PCN #: 2458 – Rev 2

PCN Title: Qualification of Assembly & Test Site Transfer, and Additional
Assembly & Test Site for Select Discrete Products

PRODUCT CHANGE NOTICE

Table 3 - Marking Code Formats

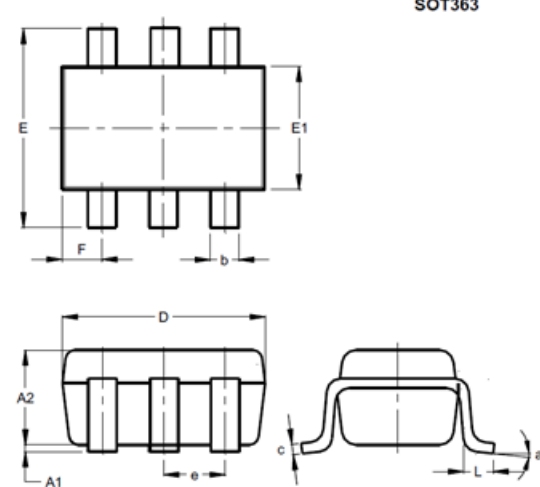
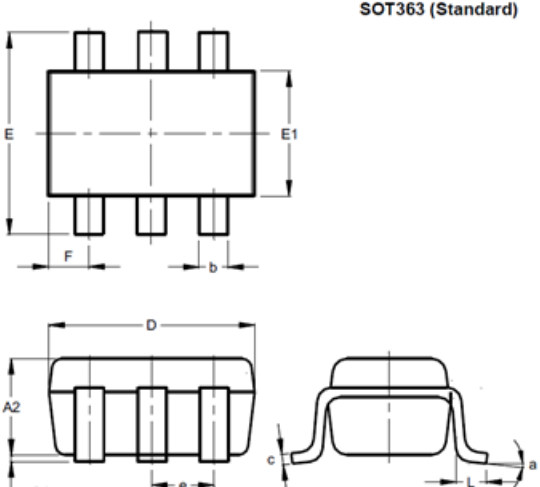
Package	Side by side comparison Logo/Marking																																																																																									
	Current Top Marking	New JCET Top Marking																																																																																								
SOT23	 <p>XXX = Product Type Marking Code YM = Date Code Marking Y or Y̅ = Year (ex: H = 2020) M = Month (ex: 9 = September)</p> <p>Date Code Key:</p> <table border="1"> <tr> <th>Year:</th> <th>2018</th> <th>2019</th> <th>2020</th> <th>2021</th> <th>2022</th> <th>2023</th> <th>2024</th> <th>2025</th> </tr> <tr> <td>Code:</td> <td>F</td> <td>G</td> <td>H</td> <td>I</td> <td>J</td> <td>K</td> <td>L</td> <td>M</td> </tr> <tr> <th>Month:</th> <th>Jan</th> <th>Feb</th> <th>Mar</th> <th>Apr</th> <th>May</th> <th>Jun</th> <th>Jul</th> <th>Aug</th> <th>Sep</th> <th>Oct</th> <th>Nov</th> <th>Dec</th> </tr> <tr> <td>Code:</td> <td>1</td> <td>2</td> <td>3</td> <td>4</td> <td>5</td> <td>6</td> <td>7</td> <td>8</td> <td>9</td> <td>0</td> <td>N</td> <td>D</td> </tr> </table>	Year:	2018	2019	2020	2021	2022	2023	2024	2025	Code:	F	G	H	I	J	K	L	M	Month:	Jan	Feb	Mar	Apr	May	Jun	Jul	Aug	Sep	Oct	Nov	Dec	Code:	1	2	3	4	5	6	7	8	9	0	N	D	 <p>XXX = Product Type Marking Code YM = Date Code Marking Y or Y̅ = Year (ex: H = 2020) M or M̅ = Month (ex: 9 = September)</p> <p>Date Code Key:</p> <table border="1"> <tr> <th>Year:</th> <th>2018</th> <th>2019</th> <th>2020</th> <th>2021</th> <th>2022</th> <th>2023</th> <th>2024</th> <th>2025</th> </tr> <tr> <td>Code:</td> <td>F</td> <td>G</td> <td>H</td> <td>I</td> <td>J</td> <td>K</td> <td>L</td> <td>M</td> </tr> <tr> <th>Month:</th> <th>Jan</th> <th>Feb</th> <th>Mar</th> <th>Apr</th> <th>May</th> <th>Jun</th> <th>Jul</th> <th>Aug</th> <th>Sep</th> <th>Oct</th> <th>Nov</th> <th>Dec</th> </tr> <tr> <td>Code:</td> <td>1</td> <td>2</td> <td>3</td> <td>4</td> <td>5</td> <td>6</td> <td>7</td> <td>8</td> <td>9</td> <td>0</td> <td>N</td> <td>D</td> </tr> </table>	Year:	2018	2019	2020	2021	2022	2023	2024	2025	Code:	F	G	H	I	J	K	L	M	Month:	Jan	Feb	Mar	Apr	May	Jun	Jul	Aug	Sep	Oct	Nov	Dec	Code:	1	2	3	4	5	6	7	8	9	0	N	D
